The Commission has issued the enclosed Amendment No. 35 to Facility Operating License No. DPR-58 and Amendment No. 16 to Facility Operating License No. DPR-74 for the Donald C. Cook Nuclear Plant, Unit Nos. 1 and 2, respectively. The amendments consist of changes to the Technical Specifications in response to your application transmitted by letter dated August 9, 1979, as supplemented December 7, 1979.

These amendments provide for the addition of a safety-related DC battery system to upgrade the turbine driven train of the auxiliary feedwater system, the upgrading of the Technical Specifications for existing safety-related batteries and the removal of a Unit 2 license condition which has been satisfied by elimination of AC dependency in the turbine driven train of the Unit 2 auxiliary feedwater system.

SAFETY EVALUATION BY THE OFFICE OF NUCLEAR REACTOR REGULATION  
RELATED TO AMENDMENT NO. 35 TO FACILITY OPERATING LICENSE NO. DPR-58  
AND AMENDMENT NO. 16 TO FACILITY OPERATING LICENSE NO. DPR-74  
INDIANA AND MICHIGAN ELECTRIC COMPANY  
DONALD C. COOK NUCLEAR PLANT UNIT NOS. 1 AND 2  
DOCKET NOS. 50-315 AND 50-316

Auxiliary Feedwater System  
D.C. Cook  
Figure 1 (Sheet 1 of 2)

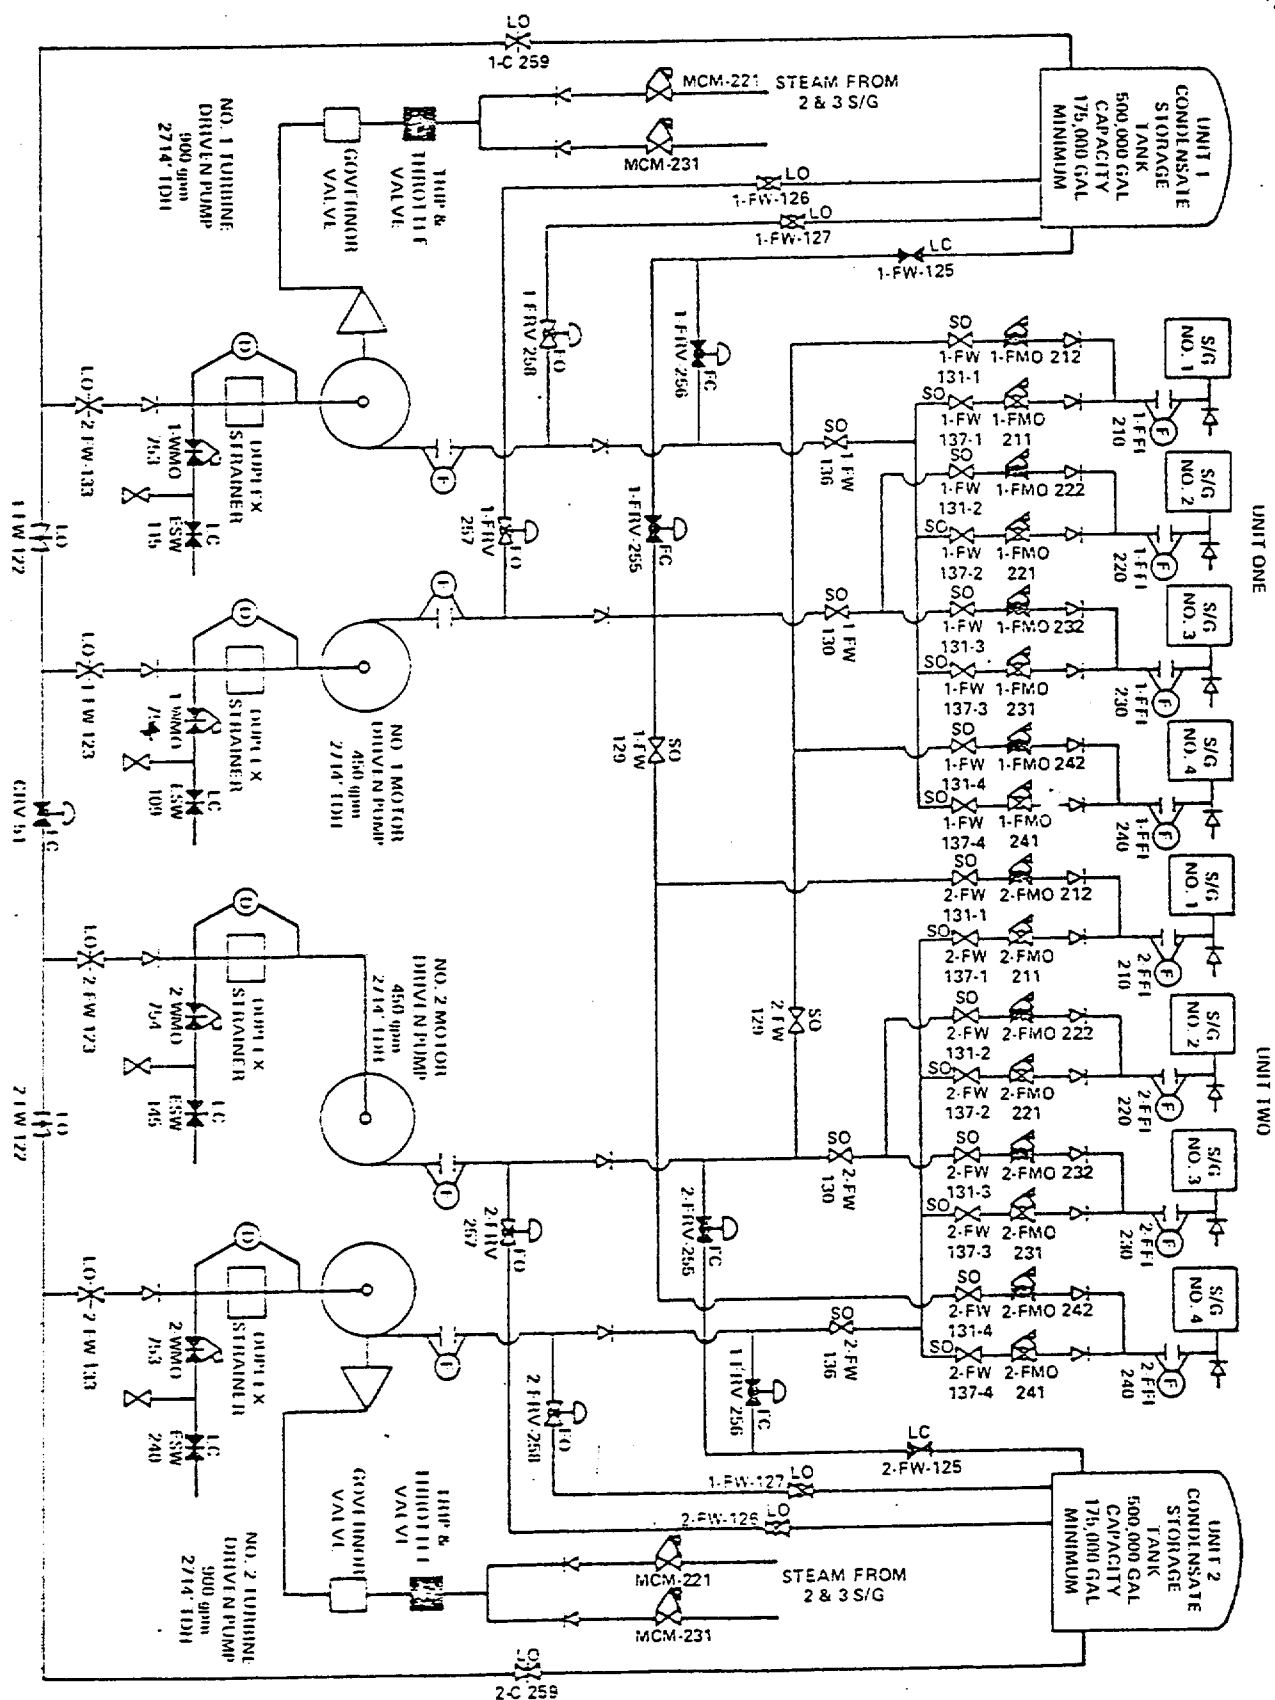
The turbine driven auxiliary feedwater (TDAFW) pump is connected to all four steam generators in Unit 2. Steam is supplied redundantly from Steam Generator Nos. 2 and 3 and taken upstream of the main steam isolation valves. The steam supply isolation valves to the TDAFW pump are MCM 221 and MCM 231; (refer to Figure 1). These 4-inch motor operated gate valves are normally open, allowing steam pressure to be available up to the trip and throttle (T&T) valve. The motor operated steam isolation valves MCM-221 and 231 can be opened or closed from the control room and on loss of power they fail as-is.

The T&T valve is normally closed and opens automatically when the TDAFW pump receives a start signal, however, it is AC powered and fails as-is. Auxiliary feedwater is supplied to the four steam generators through 4-inch motor operated valves (MOV), FMO-211, 221, 231, and 241. These globe type MOVs are normally open, but each may be closed by the control room operator in the event of a feedwater or steam line break at the steam generator it feeds. Each MOV can be throttled to regulate steam generator level. In the event of a steam line break and rapid depressurization of a steam generator, or upon detection of a high flow at the TDAFW pump, these MOVs are automatically driven to an intermediate position to prevent pump runout. On loss of power, these MOVs fail as-is.

The TDAFW pumps and associated valves are presently powered from the Class IE AC power system train B. Upon loss of all AC both onsite and offsite the AFWs could not perform its intended function. Therefore, the staff has found it necessary and the licensee has committed to eliminate dependence of the TDAFW pump train upon alternating current by converting to a direct current source of power.

The turbine driven auxiliary feed pump control bus and associated MOV motors will be powered from the "N" train battery. The following is a list of loads on the "N" train: valve - FMO - 211, 221, 231 and 241 (1.6 Hp) each; the trip and throttle valve (0.33 Hp); test valve - FRV - 256; emergency leak off valve - FRV - 258; AFW Turbine Auto Start; AFW turbine trip; and the overspeed monitor.

The two new battery chargers would be powered from separate and independent Class IE power buses. As originally proposed, either charger could have been connected to the "N" train battery under normal conditions. During our review we identified the potential for unacceptable parallel operation of both chargers which could connect redundant safety load groups in violation of Regulatory Guide 1.5. We required that at least one interlock (mechanical or electrical) be provided to prevent an operator error that would parallel these chargers. The licensee modified its design to incorporate an acceptable electrical interlock which will prevent this potential problem.

Likewise, during our review we identified another potential for paralleling two standby circuits from the existing station batteries (AB and CD) in violation of Regulatory Guide 1.6. We required that at least one interlock be provided to prevent operator error from tying these batteries together. To meet our requirement, the licensee disabled the backup feeders from the AB and CD batteries (by disconnecting and insulating the ends of the interconnecting cables). These cables were disconnected at the "N" train distribution cabinet and at the distribution cabinets for the AB and CD batteries.

With the incorporation of these modifications we conclude that the design of the TDAFW pump train complies with the provisions of Regulatory Guide 1.6.
